OUR REF 240407L26

29 CHARLES CRESCENT, TAUPŌ : FURTHER INFORMATION RESPONSE PART 2

Further to our S92 response letter of 25 September 2025, please find additional information attached and below. Specifically, see Enclosure 2 being revision C Appendix 2 being JT Design Plans. The whole set has been provided for completeness with the only plans altered being:

Image 1: Map Contours of Clarke Grove Properties

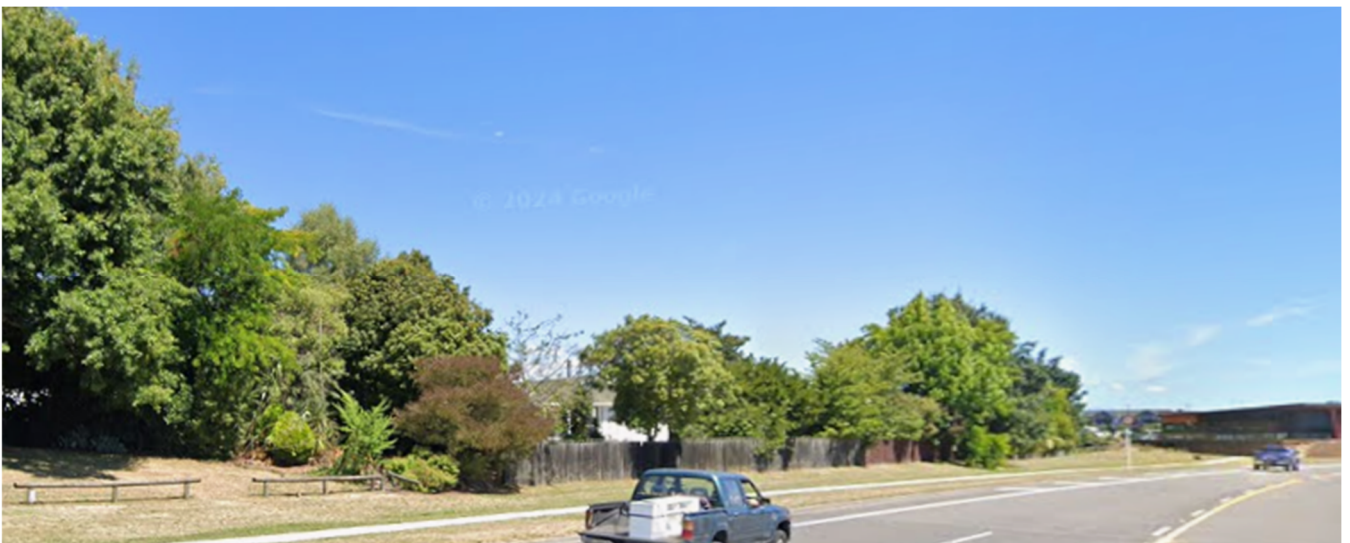
1. Photo montages which show the proposed development in the context of the surrounding area.

Further to the assessment provided in Sections 6.4 & 7.3.3 regarding the properties at Grace Crescent, we note that the properties at 31 Grace Crescent and 4 & 5 Clarke Grove also sit at RL 375 approx., being approx. 4m higher than the site's design FFL (Image 1).

These properties are 1 to 2 storeys and have their outdoor living areas towards the north with some windows facing west. As noted in the photos, they have significant vegetation along their western/Lake Terrace frontage (Images 2 & 3). These properties are 87.5m from the boundary of the site and therefore their amenity is not affected by height, height to boundary nor are they affected by the proposed density. They will see the proposal within the wider context of the built environment of Rainbow Point at a distance of 80m – 90m, in their side view. These parties are considered unaffected by the proposal.
